Thank you for contacting the City of Sammamish regarding the current Shoreline Substantial Development Permit Application for East Lake Sammamish Trail Segment 2B (SSDP2016-00415).

Per our meeting with Kelly Donahue, King County Department of Natural Resources, I am sending you this letter to document two unacceptable errors at location 355 in the ELST 60% build plan. They are:

Review of Sammamish Trail Plans Near Location 457

Figure 5: Flow durations for existing conditions and proposed drainage improvements. Flow control will be required during the design phase to match existing durations.

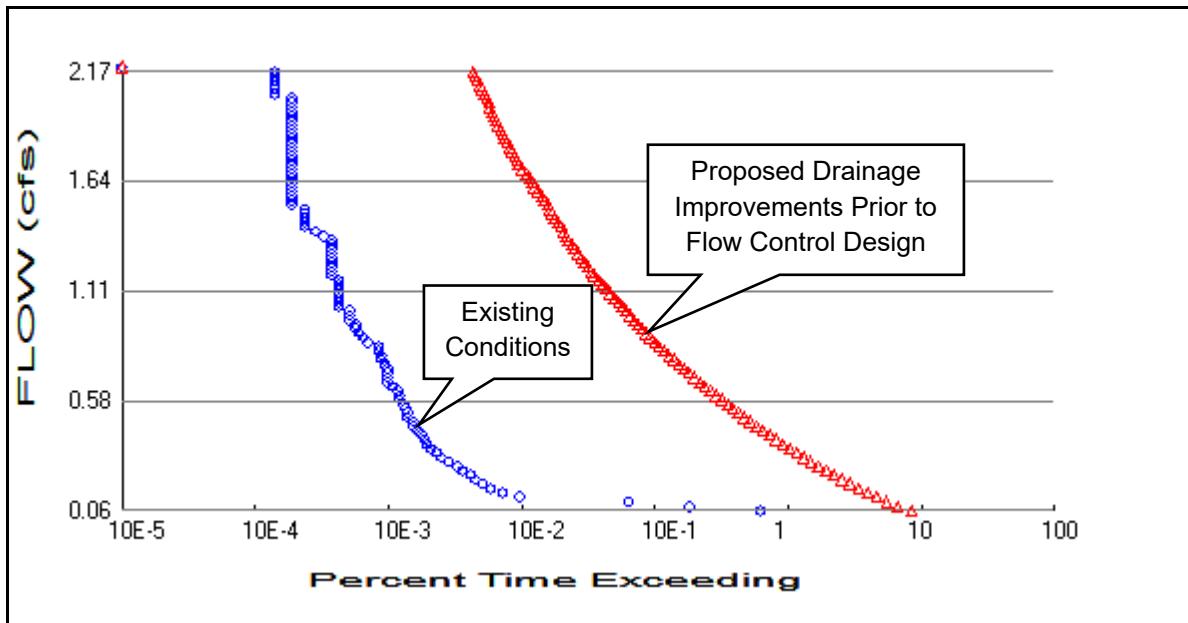
A comparison of flow durations for existing conditions and proposed drainage improvements is shown in **Figure 5**. Flows durations are expected to exceed the existing conditions . This exceedance is a result

of the flows from Subbasins 7 and 8 being piped directly to the outlet of Subbasin 4, rather than being allowed to partially infiltrate in Subbasin 4. The exceedance in flow durations create an erosion concern for the small wetland and downstream channel sections near the Lake Sammamish outfall. Flow control to match existing durations will be needed as part of the proposed drainage improvements in order to protect the downstream channel.

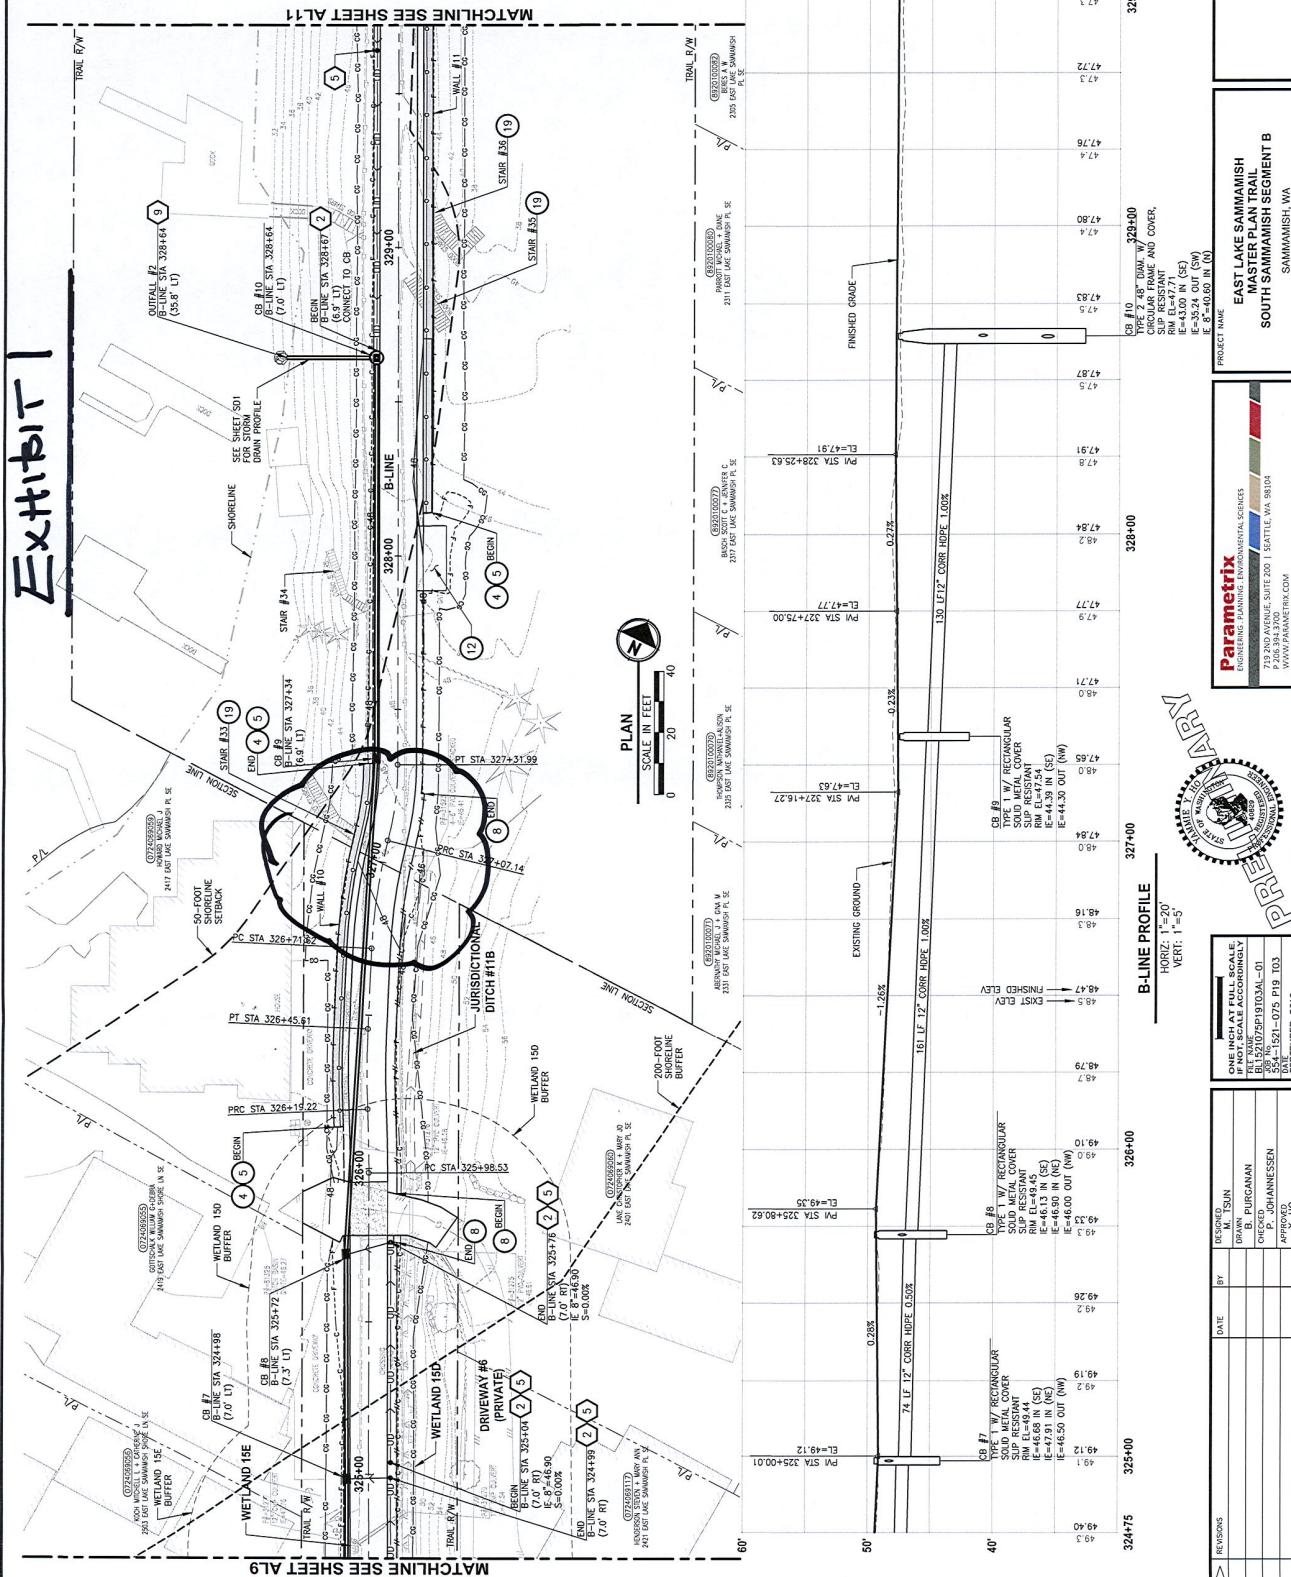
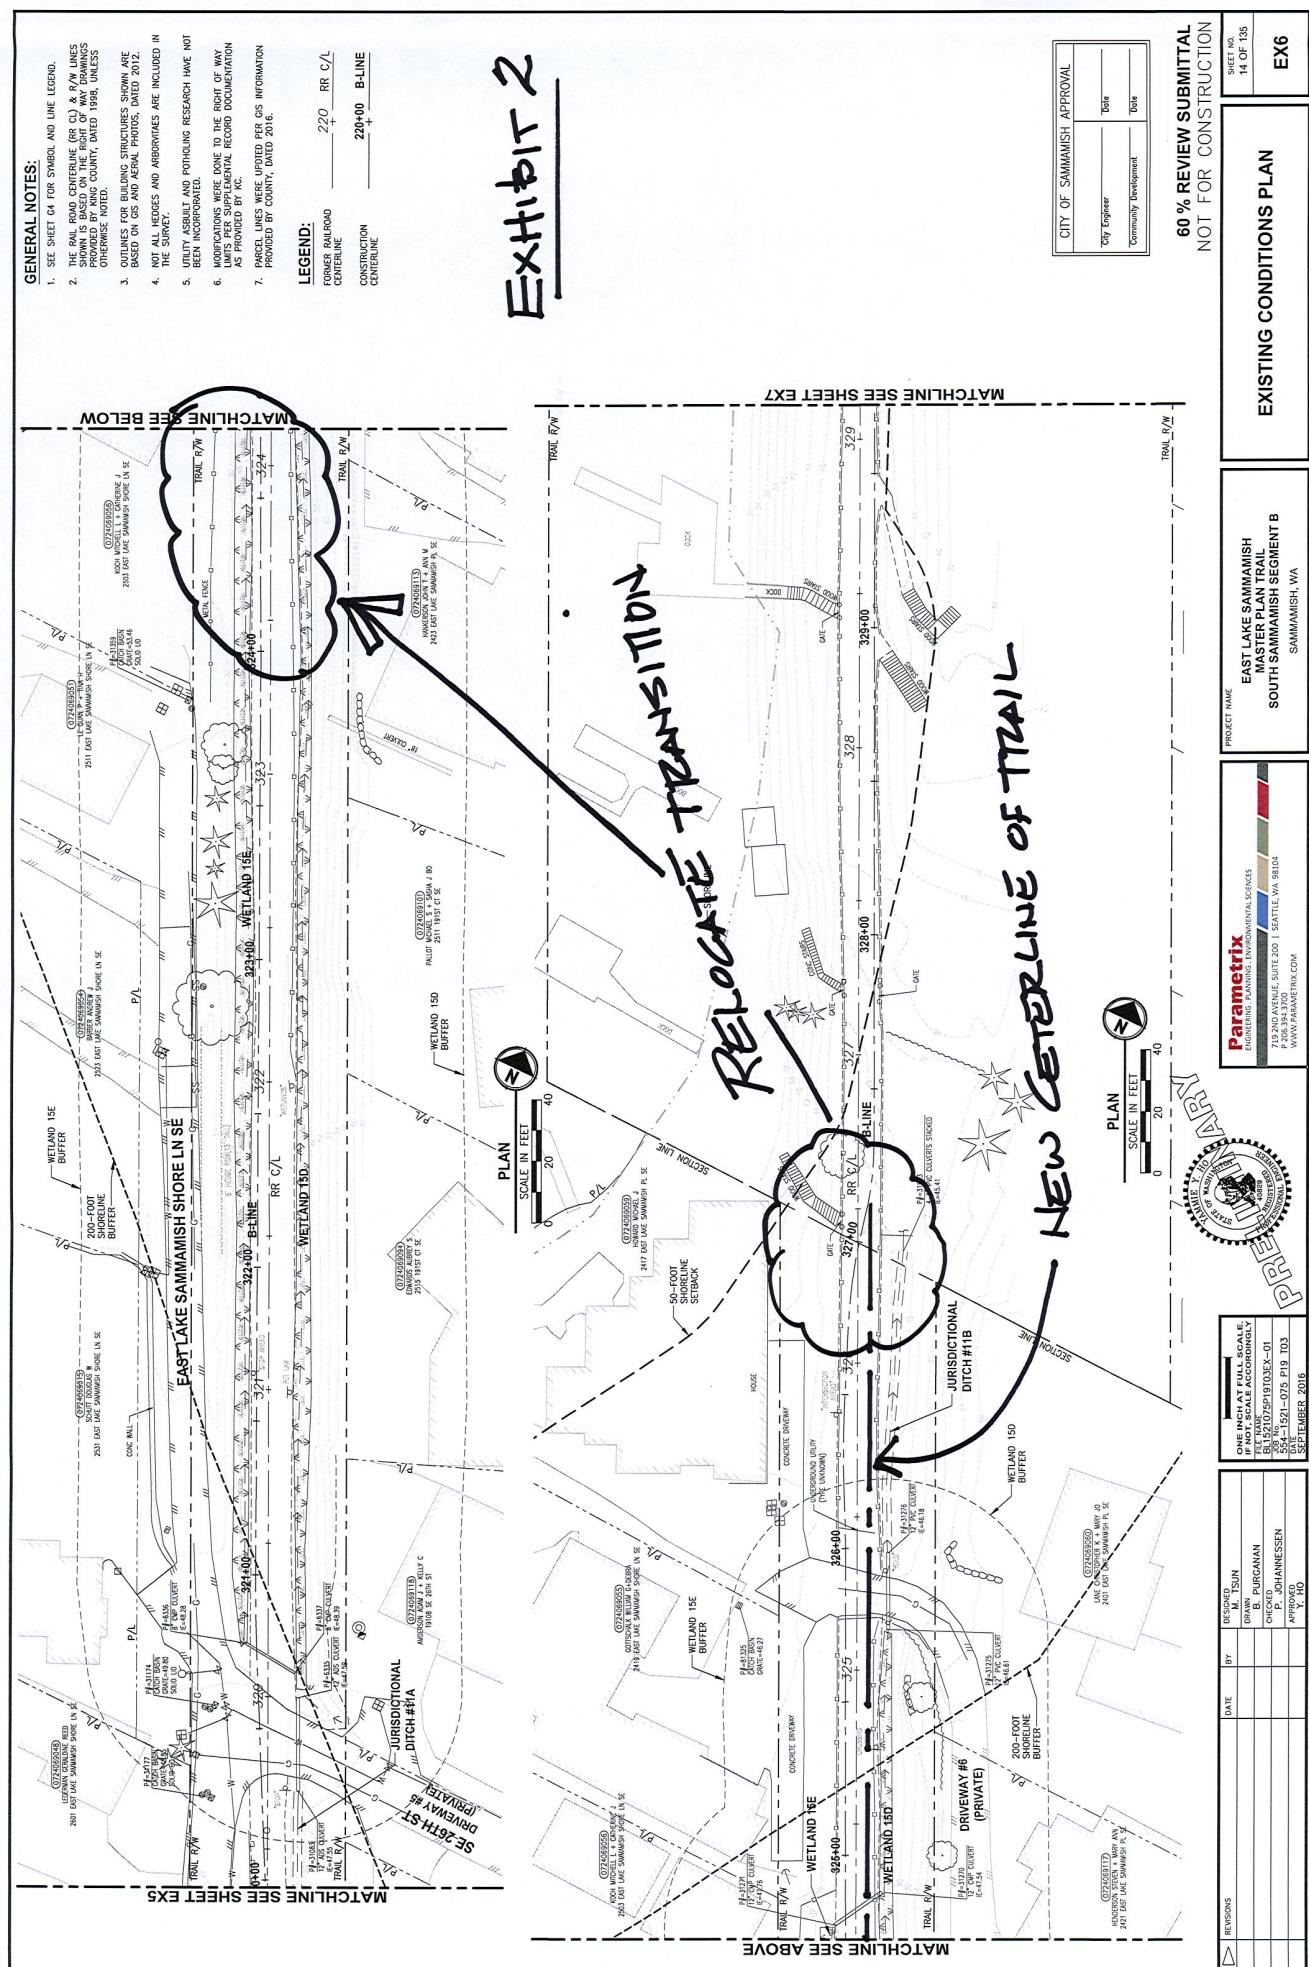
- **Clearing and Grubbing Limits** – My clients also propose that the clearing and grubbing lines be modified to correspond to my clients' preferred Trail realignment. My clients' proposed modifications are depicted on the attached Exhibit 3. Further, the clearing limits should be adjusted to follow the course of the Trail in order to prevent and/or limit, any adverse impacts to my clients' existing stamped concrete driveway, irrigation, drainage, and landscape lighting.
